Custom D/F Illuminated Monument

RE: S14-07-S-B (PDR-2022-00052) City Gate CSP Amendment

Project: City Gate
Revision to Comprehensive Sign Plan
Narrative Letter for Minor Administrative Amendment

Comprehensive Sign Plan

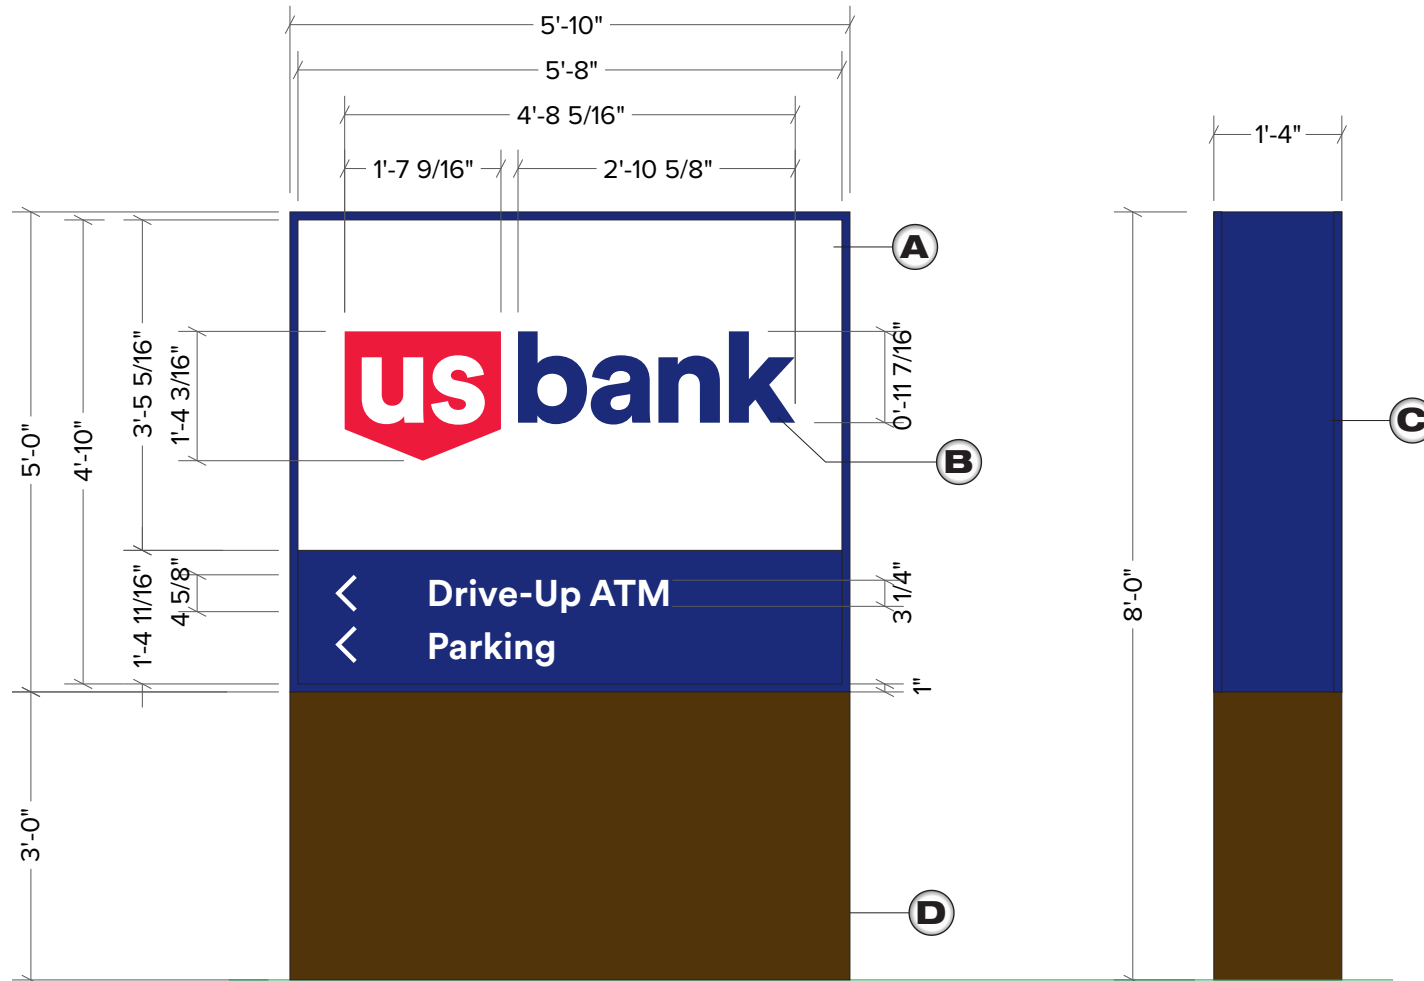
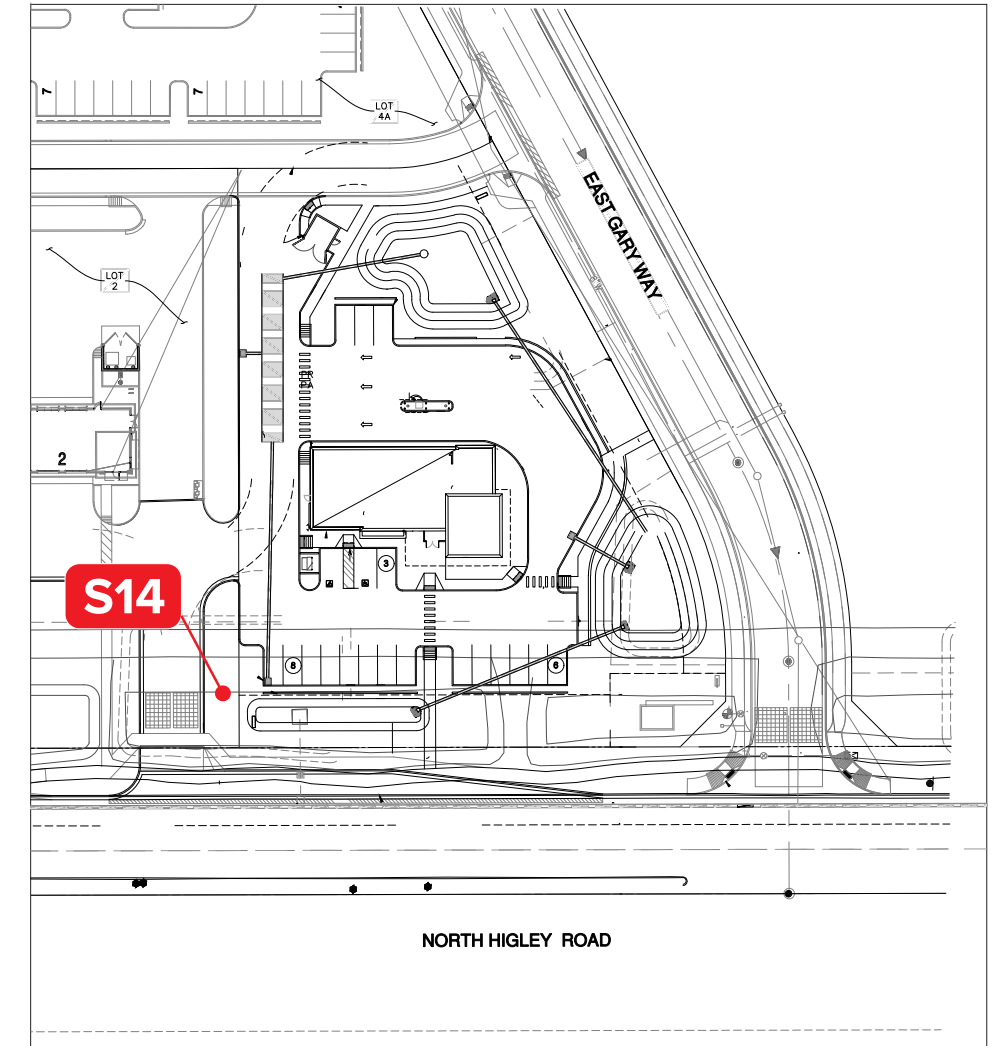
Install new custom d/f illuminated monument.
 NOTE: Base must comply with Master Sign Plan

| Revisions: | |
|--------------------------------------|---|
| Revised monument size - RF - 8/16/24 | X |

SITE PLAN **02**

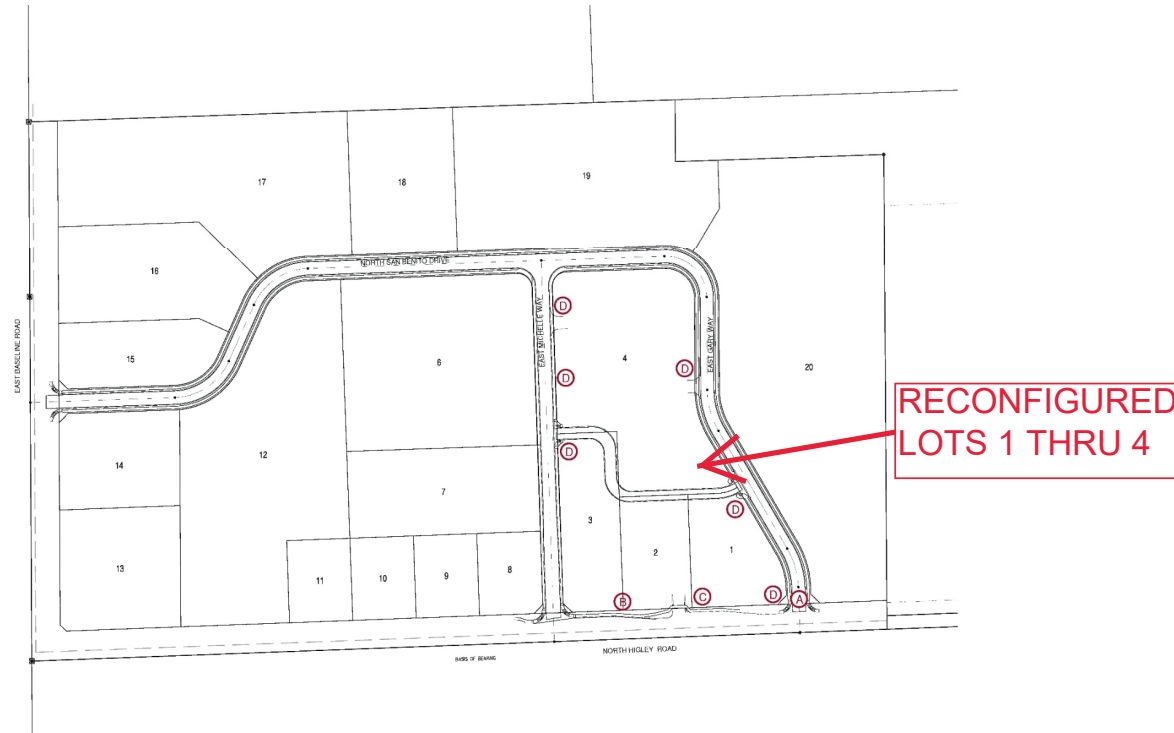
| 1) Sheet Site Plan 02 | Reconfigured lots 1 thru into new lots 1 thru 4 |
| 2) Sheet Site Plan 02 | Replaced C sign on south side of lot 4 with D sign SE corner lot 1 |
| 3) Sheet Site Plan 02 | Added C sign NW corner lot 1 |
| 4) Sheet Site Plan 02 | Added D sign north side of lot 4 |
